## Index 400 Guardrail

### COMMENTARY

Sheet 20: add details for terminating pipe rail on steel posts

**BLACK** = Industry Review Comments    **RED** = Standard Plans Response

**POST AND OFFSET BLOCK DETAILS**

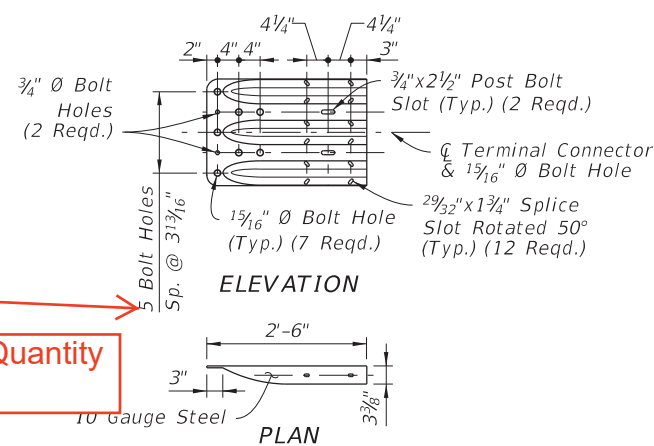
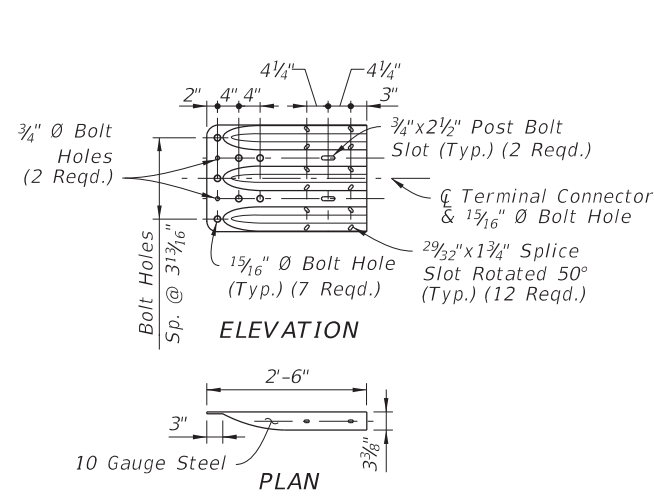
- a. Does 13/16" hole size substitution per Sheet 5 apply on Sheet 21?

1. Sheet 5 of 22: Recommend to maintain the 13/16 in. bolt holes specification for steel posts and steel block since holes are pre-drilled the greater diameter will allow for hole alignment adjustment without field modification.

- 6) PDF Index 536-001 Sheet 21 of 22
  - a. Backwards compatibility to 13/16" holes are applicable to this Special Steel Post, where the hole layout and function are identical to Standard Posts it is substituting for per Note 1. We will update Note 3 on Sheet 5 to further clarify applicability.

- 1) The 13/16" bolt hole size is still permitted. It is being maintained for backwards compatibility per the new Note 3 on Sheet 5 (Note: The default 3/4" bolt hole follows the national MGS design). Okay as-is.
- 2) Nested panels have historically been a common practice, and the new General Note has a sufficient description. Okay as-is.
- 3) We've made the 1:10 max callout less prominent, particularly on shoulders, in order to avoid the interpretation that 1:10 max is the only shoulder slope requirement.

**THRIE-BEAM TERMINAL CONNECTOR DETAIL**

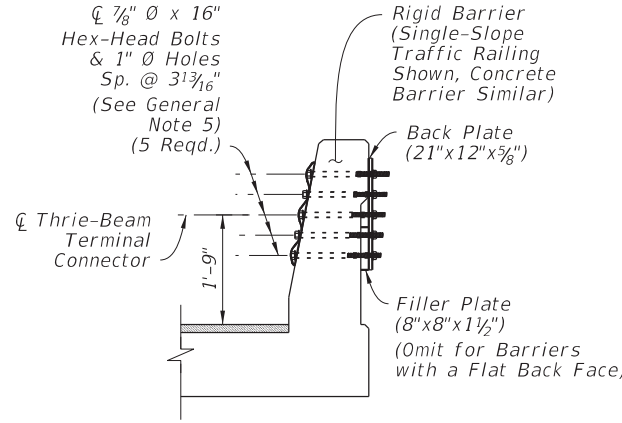
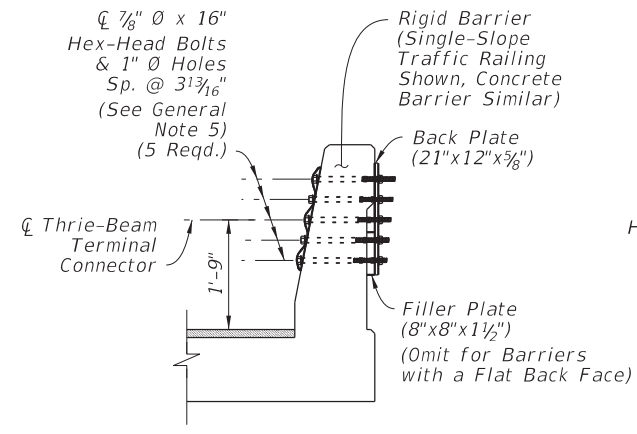
- 2) PDF Index 536-001 Sheet 11 of 22
  - a. See number 1 above
- 3) PDF Index 536-001 Sheet 15 of 22
  - a. Hole Layout: On Thrie-Beam Terminal Connector, callout looks to say 5 bolt holes, but 7 are shown.

Removed Quantity "5"

- 1) Summary of the changes (Origination Form, Sheet 2)
  - a. Sheet 11: Correct. The 6'-0" CRT post option made it into the previous Errata on Sheet 12 (it references from Sheet 11).
  - b. Sheet 15: Correct. This wasn't required on Sheet 15.
- 2) PDF Index 536-001 Sheet 11 of 22
  - a. See number 1 above
- 3) PDF Index 536-001 Sheet 15 of 22
  - a. Hole Layout: The callout refers to 5 rows of bolt holes (only 5 bolt holes are used). This is the same Standard piece RTE01b that's been in use for prior decades (<http://mwrsf-ga.unl.edu/attachments/575de1d94ad6db47b4300e40ddf86c7c.pdf>) Since this is a Standard piece that manufacturers have been producing for past decades to accommodate Florida and other states, the FDOT is continuing use of this standard piece without changing its configuration. The callout will be revised to remove the quantity to avoid misinterpretation.
